DOCKETED	
Docket Number:	11-AFC-04
Project Title:	Rio Mesa Solar Electric
TN #:	233562
Document Title:	Applicant's Supplemental Response to Data Request 16 and 26 Additional Information Regarding Geologic Hazards and Resources
Description:	Document was on proceeding webpage and is now moved over to the docket log.
Filer:	Marichka Haws
Organization:	California Energy Commission
Submitter Role:	Commission Staff
Submission Date:	6/19/2020 3:30:28 PM
Docketed Date:	6/19/2020

# APPLICANT'S SUPPLEMENTAL RESPONSE TO DATA REQUEST 16 AND 26: ADDITIONAL INFORMATION REGARDING GEOLOGIC HAZARDS AND RESOURCES

```
Figure 5.4-1 <u>(rev)</u> Geologic Map
Figure 5.4-2 Regional Fault and Epicenter Map <u>(no changes)</u>
```

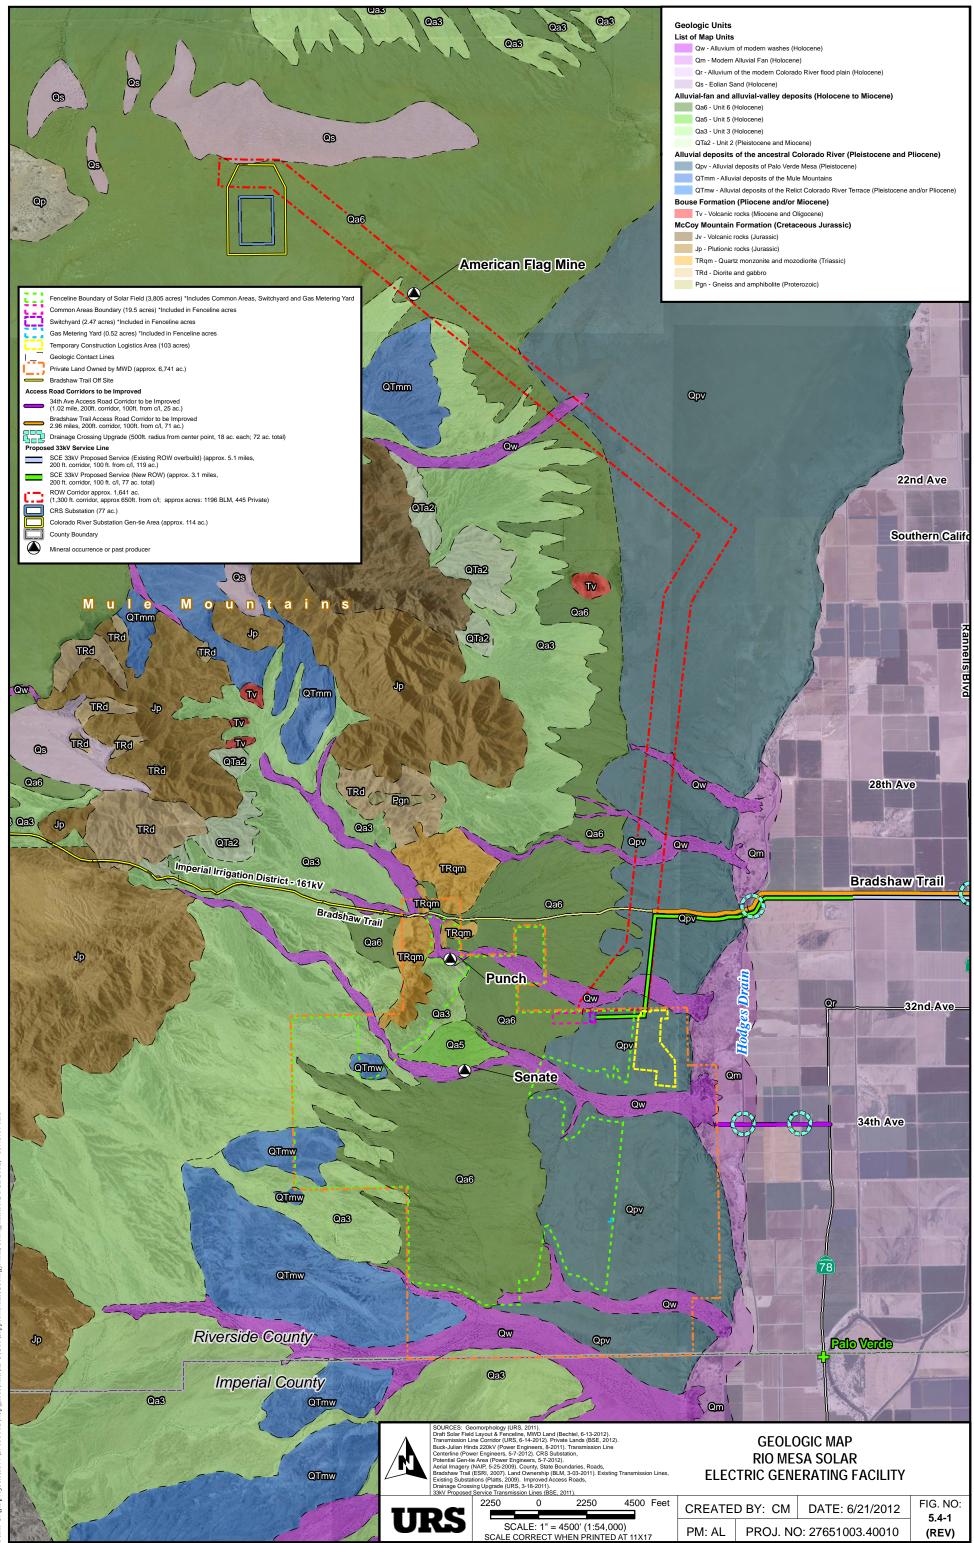
Mineral Resource Zones (MRZs) are delineated in the area by the California Department of Conservation Division of Mines and Geology (CDMG, 1994). The majority of the project area is designated as MRZ-4. These are areas of no known mineral occurrences where geologic information does not rule out either the presence or absence of significant mineral resources. However, a-portions of the Mule Mountains approximately one mile near the northwest corner of the main project site areis designated MRZ-3a. MRZ-3a areas contain known mineral occurrences of undetermined mineral resource significance. Further exploration work within these areas could result in the reclassification of specific localities into more significant categories. The mineral occurrences in these areas are identified within the mountainous terrain; however, with the designated MRZ-3a areas extendings east into the surrounding alluvial material; however, the MRZ-3a areas do not extend and onto the northeast corner of the project site.

The Project will not result in a loss of availability of a known significant mineral resource that would be of value to the region and the residents of the state. As discussed in Section 5.4.3.4, a-MRZ-3a areas are

mapped extends onto the northwest corner of the project area, with . However, the portion of the zone within the site contains alluvial deposits, while the identified mineral occurrences are located in the Mule Mountains. It is unlikely that any similar mineral occurrences are present in the alluvial terrain on the site. Further, the Palo Verde Valley Area Plan of the RCGP (Riverside County, 2003) indicates there is no significant mineral resource within the project area. The Project will not result in a loss of availability of a known significant mineral resource that would be of value to the region and the residents of the state. The Project is anticipated to have less than significant impact to geological resources.
